Response to Planning Consultations

The following pages address clarifications and comments raised through the planning consultation process.

THE
CHOCOLATE
FACTORY

Project The Chocolate Factory Wood Green			
Drawing Title Proposed Plan Block B Ground Floor			
Date 26/04/17	Scale 1:200 @ A1	Drawn by RA	Check by MK
Project No 25021	Drawing No PL-BB-100	Revision B

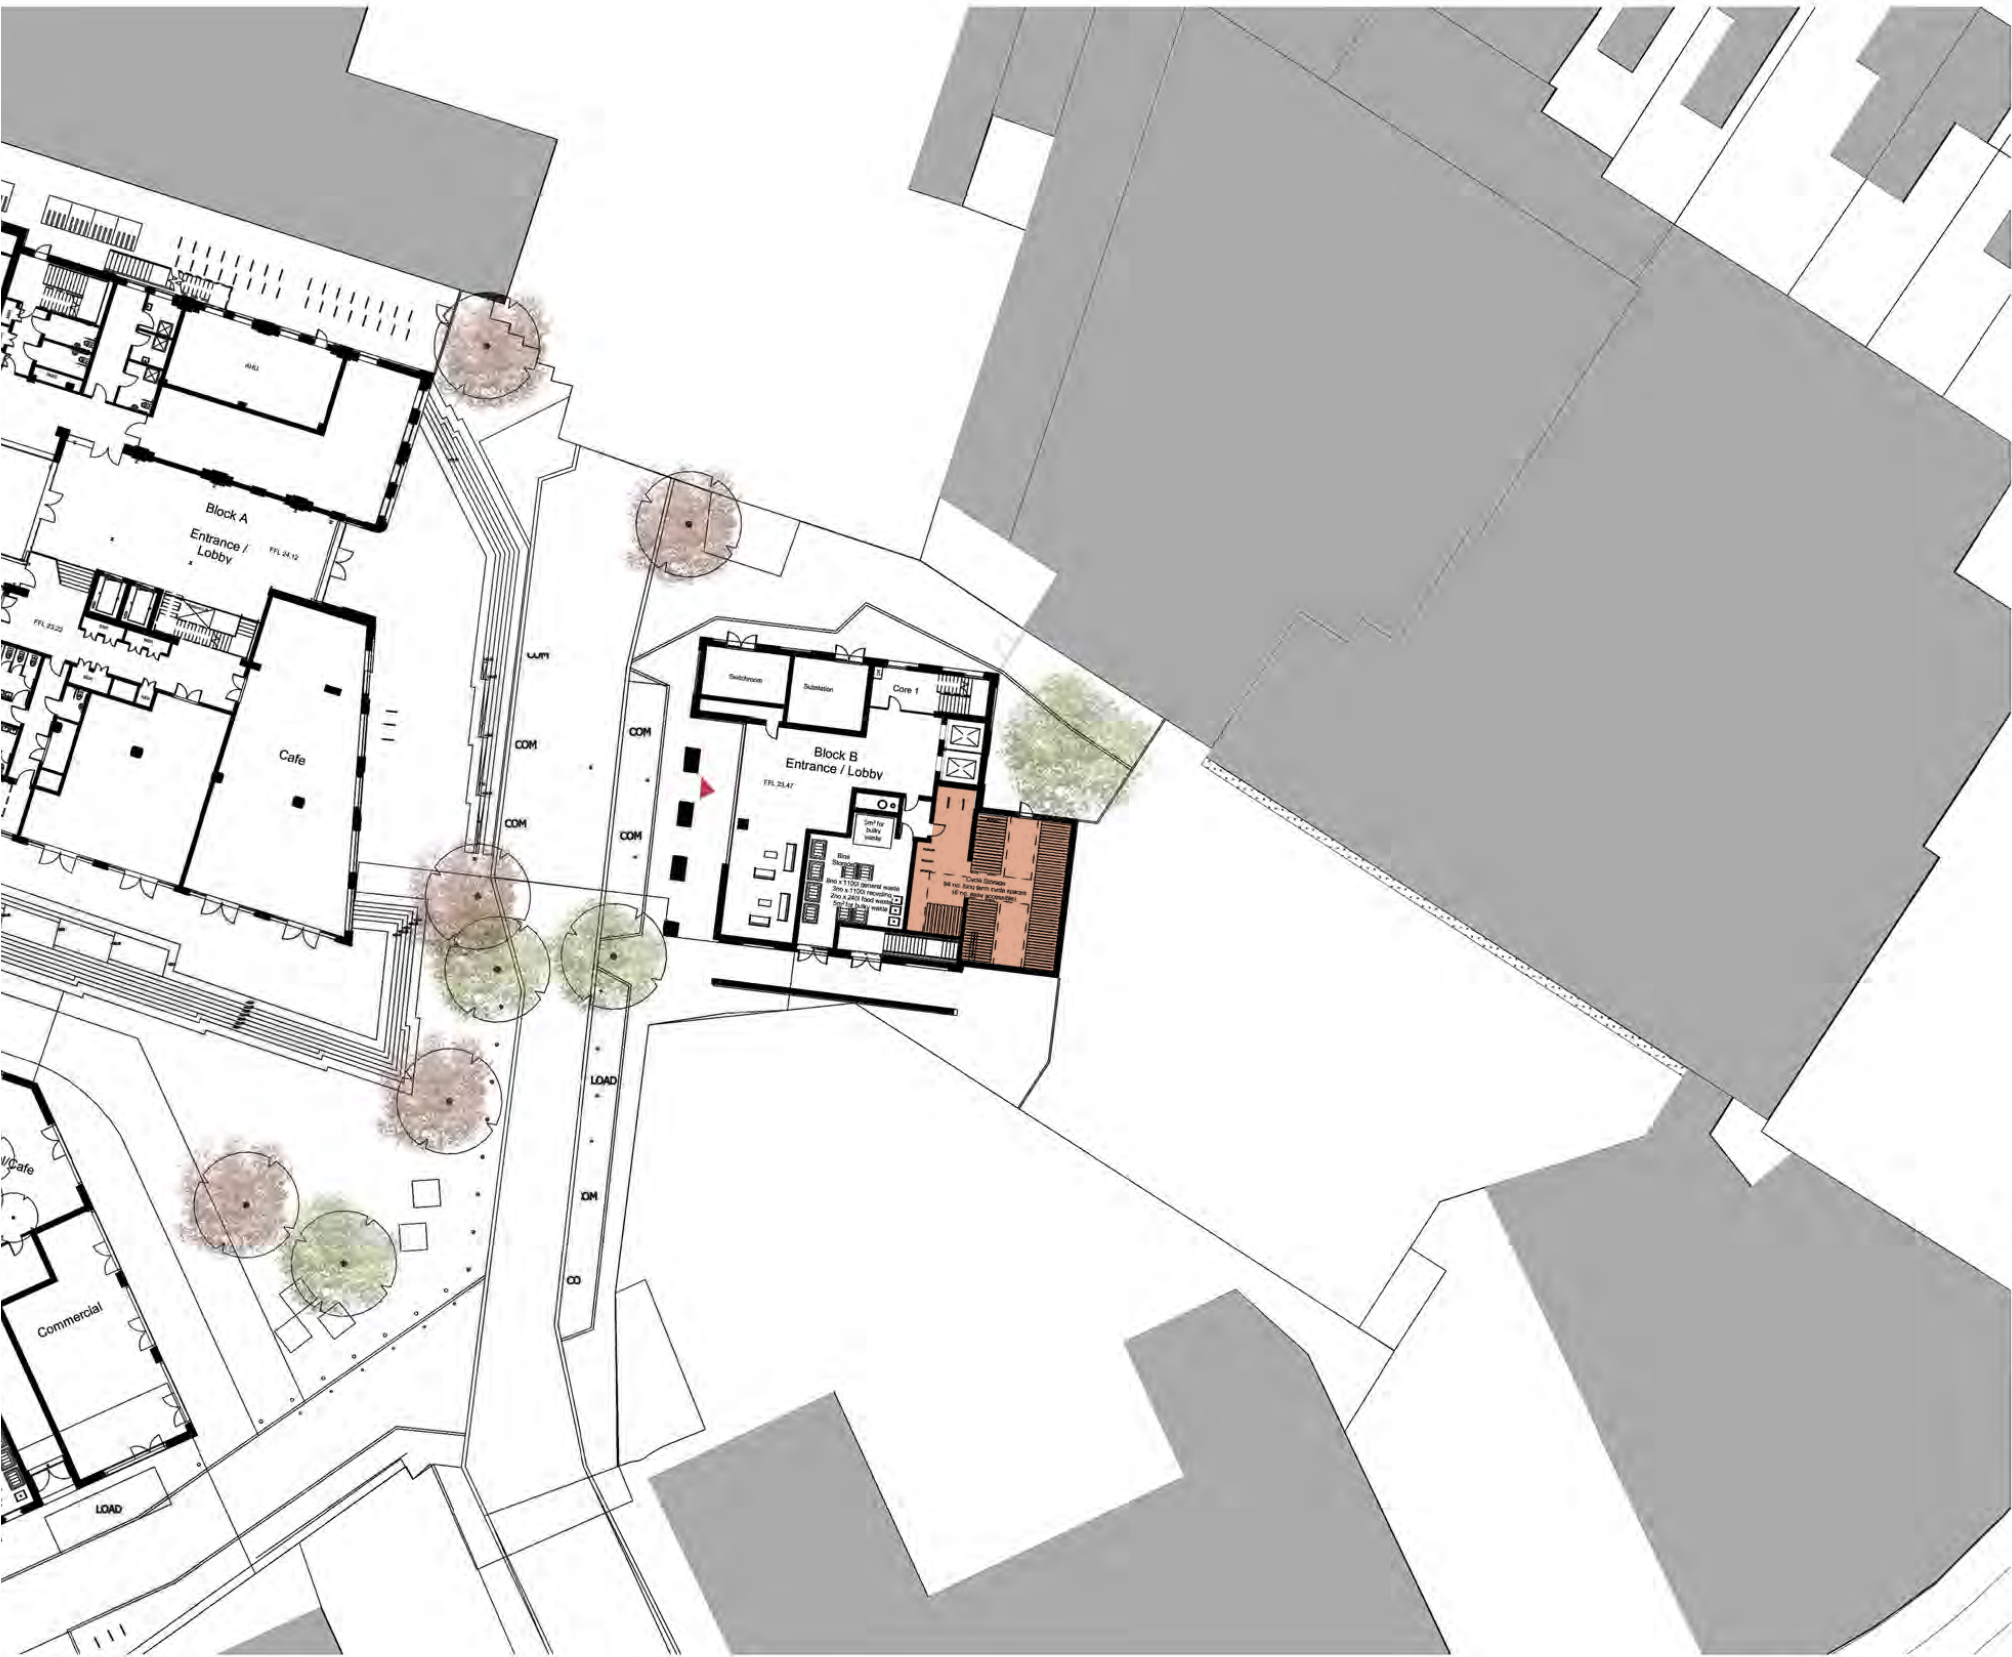
- 1. We also have accessibility concerns regarding the cycle parking highlighted in Figure 2 [Block B]– the operation of the two tier racks may block access to the nearby cycle racks.
- 2. Whilst the Transport Assessment states that a mix of cycle parking stands will be provided to cater for larger models of bicycles, this does not appear to be reflected on the plans.

- 1. Access to cycle store in Block B and the operation of the two tier racks have been improved and the bike racks organised to minimise congestion.
- 2. Space for larger bikes have been provided in all cycle stores (standard sheffield stands).

Chocolate Yard

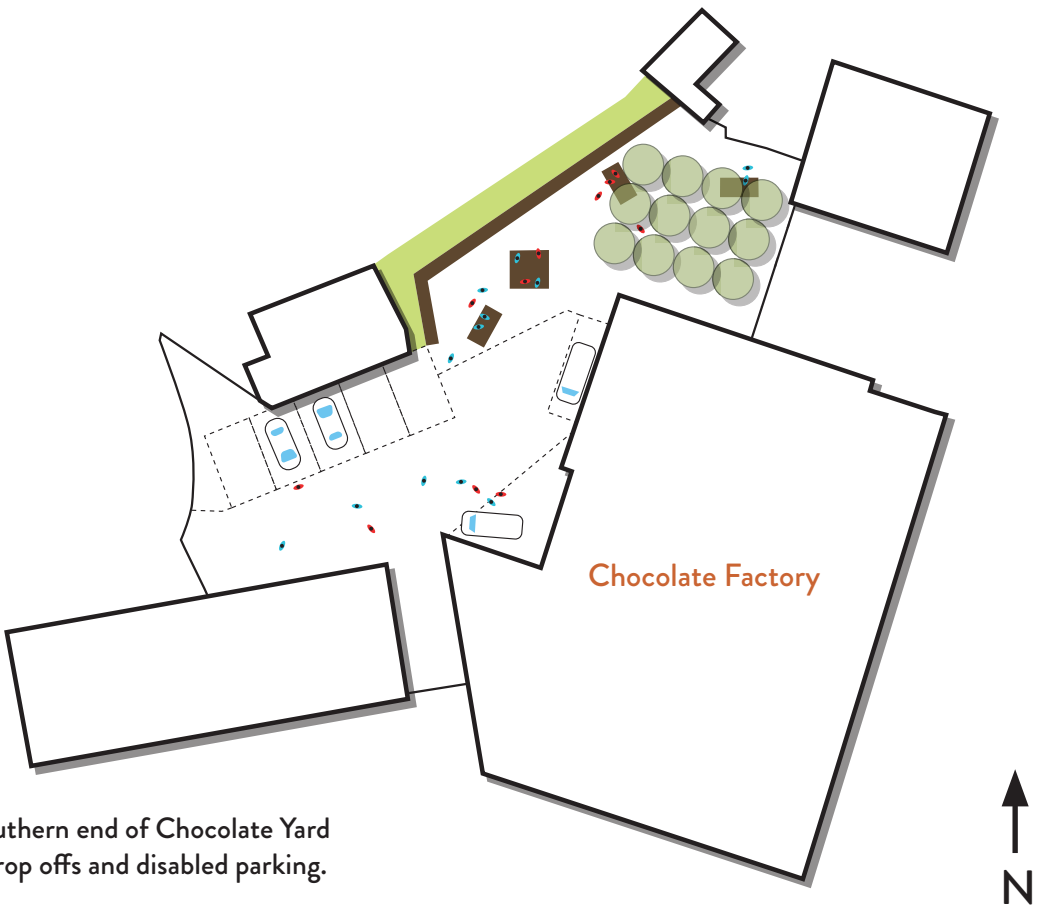
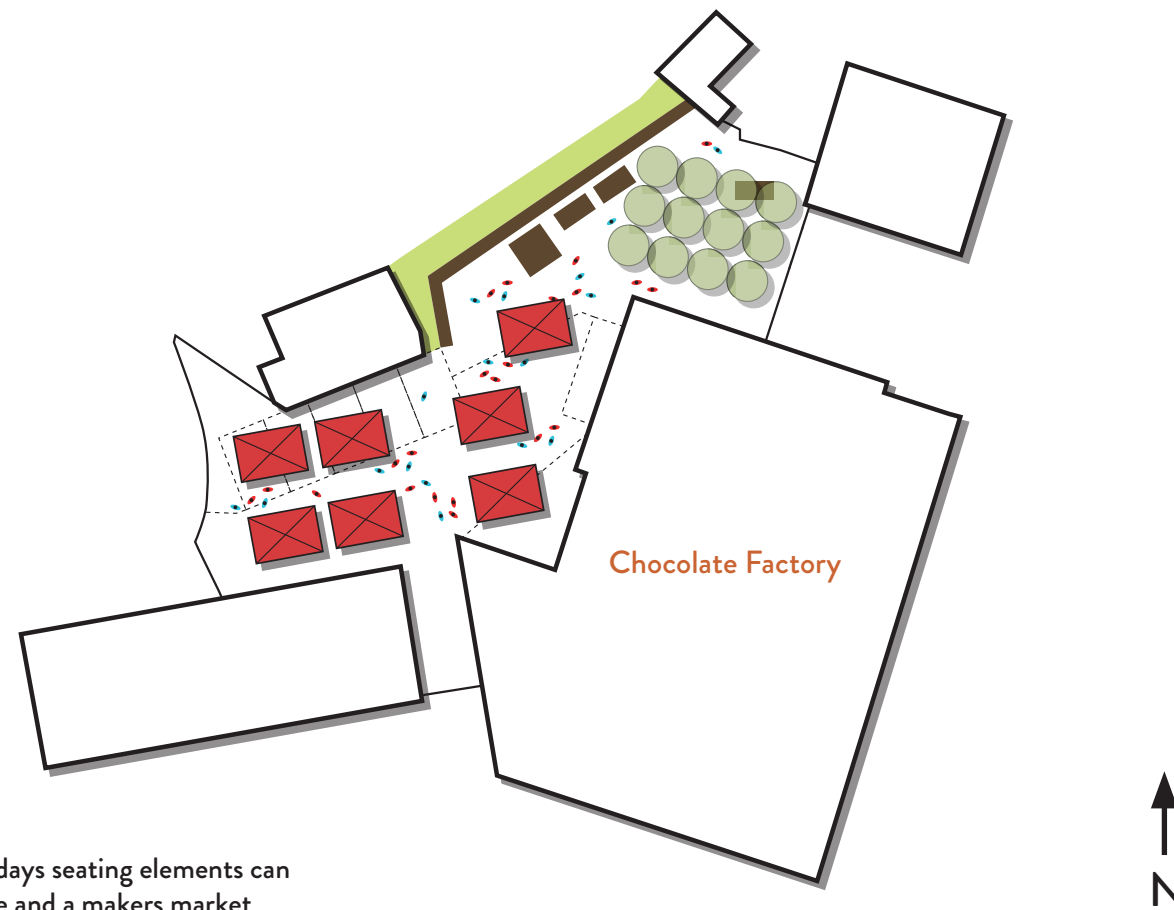
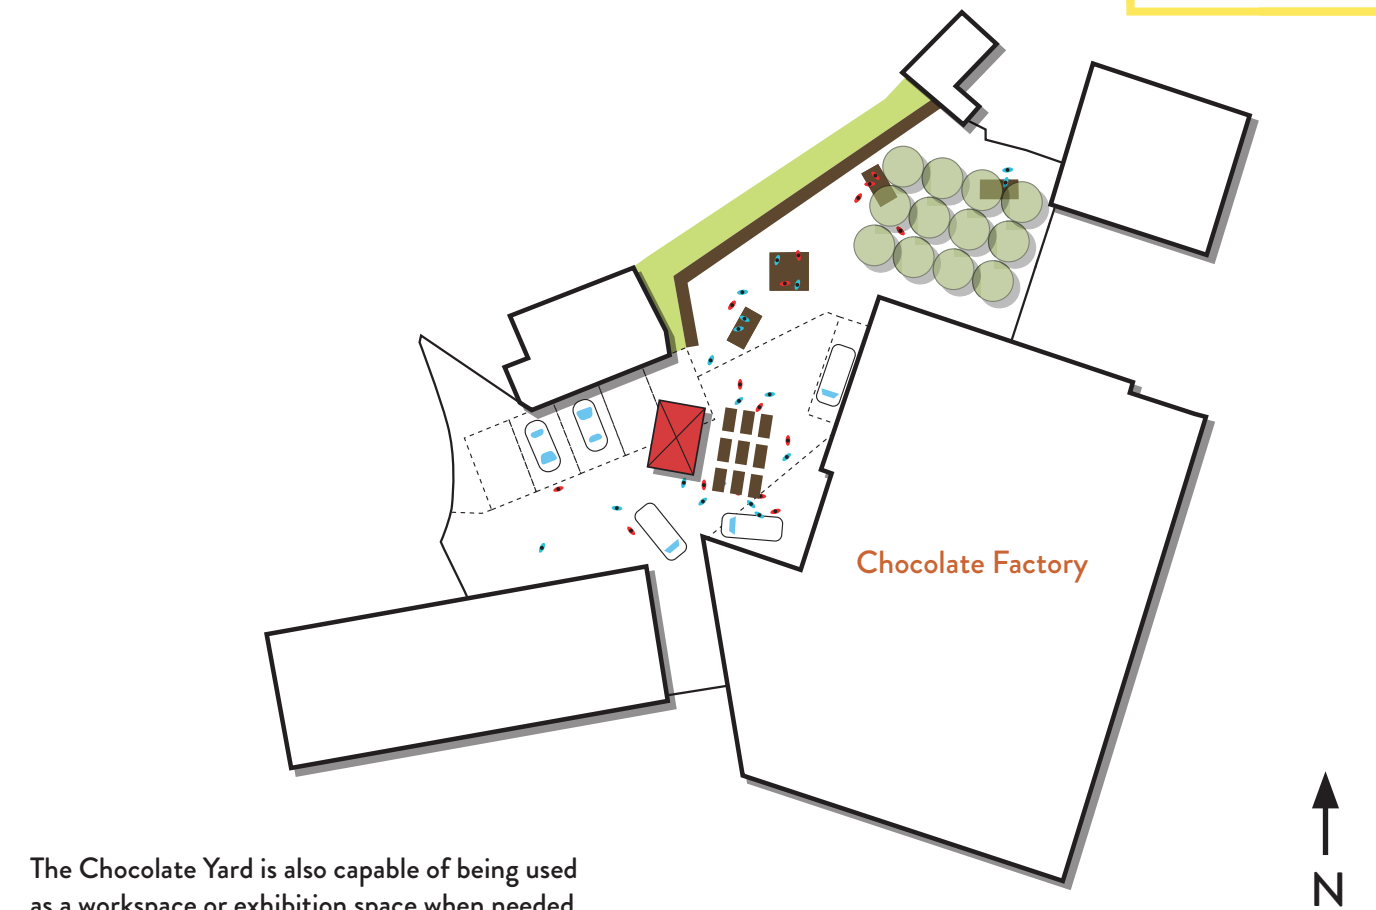
Comments returned from planning consultation requested further clarification on the intention for Chocolate Yard.

Through a rigorous management programme implemented by Workspace, the Chocolate Yard can be configured for a number of different uses, such as market days, workshops and gatherings which can all be catered for in this flexible space.

During everyday use the southern end of Chocolate Yard accommodates deliveries, drop offs and disabled parking.

In the northern end a green area with flexible seating can be used for eating out at lunchtime and as a space to relax away from the office.
